**TOWN OF NEWBURGH
PLANNING BOARD
TECHNICAL REVIEW COMMENTS**

PROJECT: HURLBURT TWO LOT SUBDIVISION
PROJECT NO.: 17-9
PROJECT LOCATION: SECTION 4, BLOCK 2, LOT 41.22
REVIEW DATE: 27 APRIL 2017
MEETING DATE: 4 MAY 2017
PROJECT REPRESENTATIVE: TALCOTT ENGINEERING

Re: Resubmission letter
Town Project No. 2017-09
Hurlburt Two Lot Subdivision
Pressler Road
SBL: 4-2-41.22
RR Zone
Job No. 17020-MEH

Response to Town of Newburgh Planning Board Review Comments review dated 2/10/17

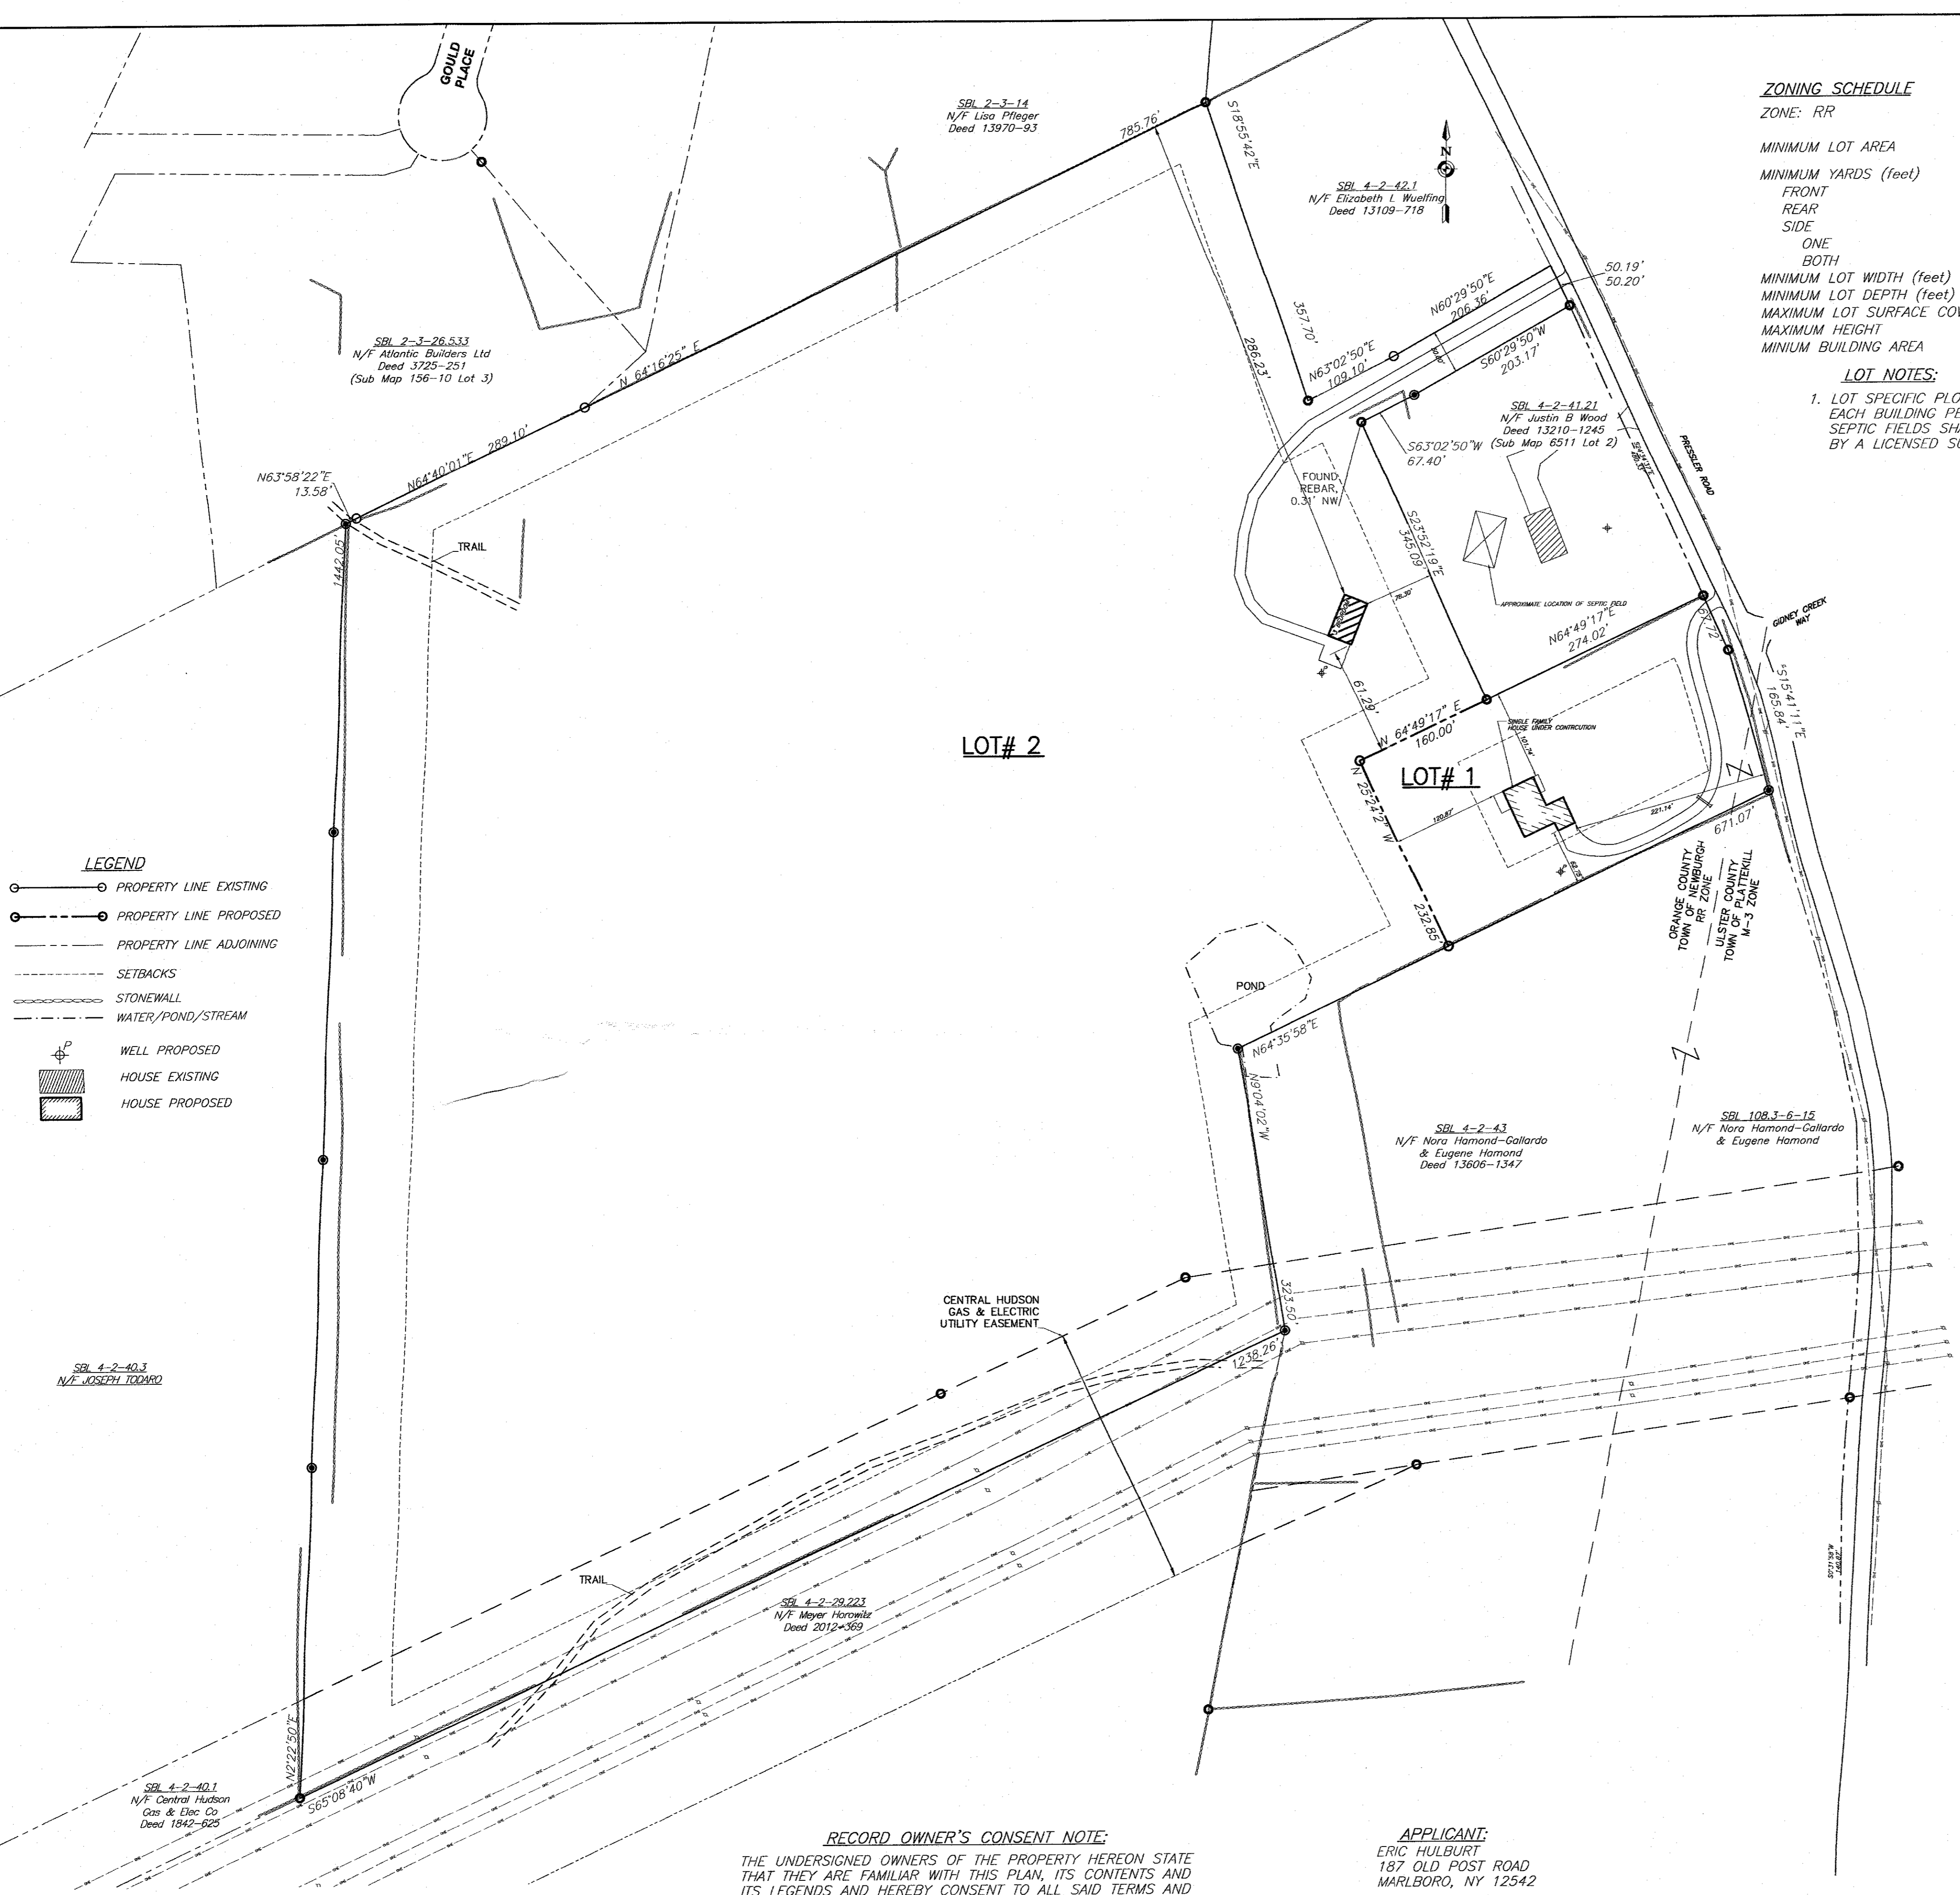
- 1) (No response required)
- 2) (No response required)
- 3) (No response required)
- 4) The house is labeled as a three bedroom on sheet 2.
- 5) The expansion area offset to the property line is labeled on sheet 2 and a note has been added to the septic design requiring stake out of the expansion area if it is to be used.

- NO. OF BEDROOMS- 3max
- SEPTIC TANK DESIGN- 1,250 gal.
- STABILIZED PERCOLATION RATE-31-45min/inch
- FLOW RATE (GALS /DAY)-330
- DESIGN LENGTHS: 6 LATERALS @ 55' = 330ft.(330ft. required)
- SHALLOW SEPTIC SYSTEM
- SURVEY STAKE OUT OF THE EXPANSION AREA IS REQUIRED IF EXPANSION IS EVER CONSTRUCTED
